ADDENDUM NO. 1 TO PROJECT NO. 44479

ELECTRICAL WORK

**PROVIDE EMERGENCY GENERATOR IMPROVEMENTS
MARCY CORRECTIONAL FACILITY
OLD RIVER ROAD
MARCY, NEW YORK 13403**

February 28, 2014

PORTABLE GENERATOR YARD AND BUILDING 20 - NEW WORK

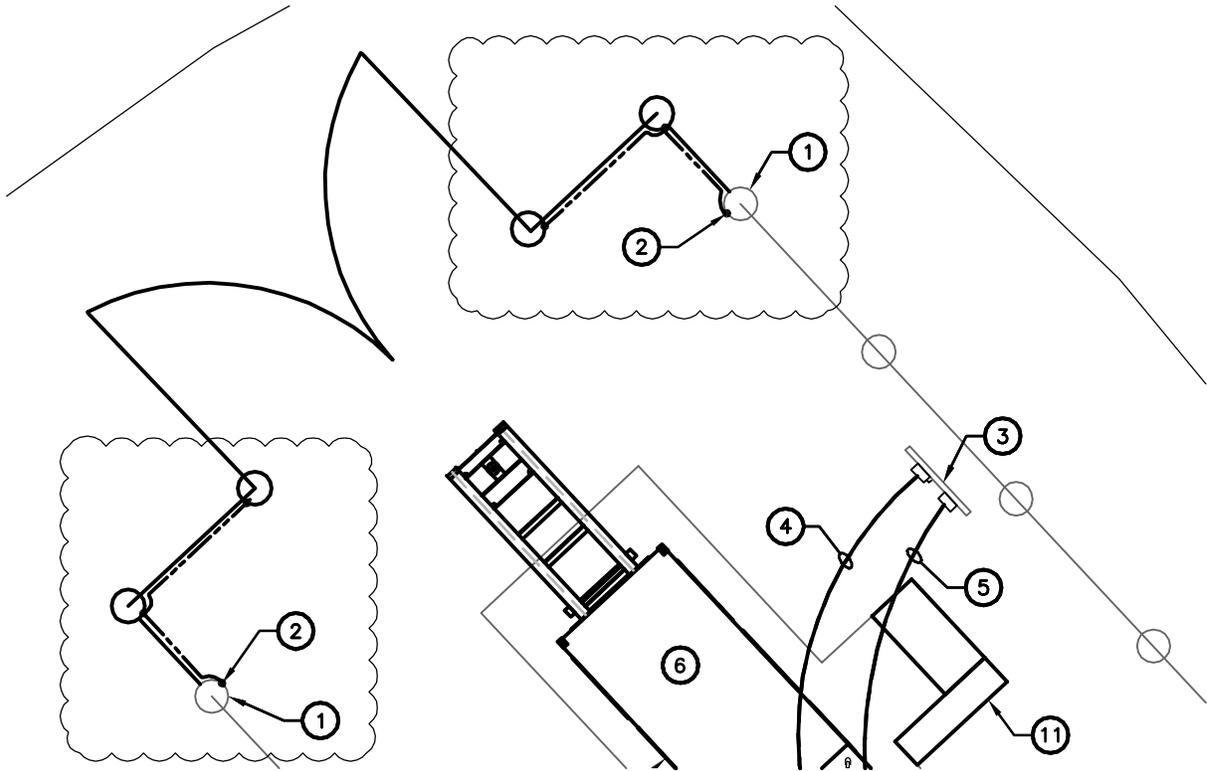
3. Drawing No. E-401: ELECTRICAL SYSTEM EXISTING CONDITIONS, NEW WORK AND YARD WORK: Revise “PORTABLE GENERATOR YARD AND BUILDING 20 – NEW WORK” per attached sketch SK-E401, as related to fence post grounding Drawing Notes 1 and 2.

- ② PROVIDE #2/0 AWG GROUND CONNECTION FROM THE NEW FENCE POSTS TO THE EXISTING GROUND TAIL LOCATED AT THE EXISTING CORNER FENCE POSTS. THE #2/0 AWG GROUND CONDUCTOR SHALL BE SECURED TO THE BASE OF THE CHAIN LINK FENCE AND ROUTED AS CLOSE TO GRADE AS POSSIBLE.
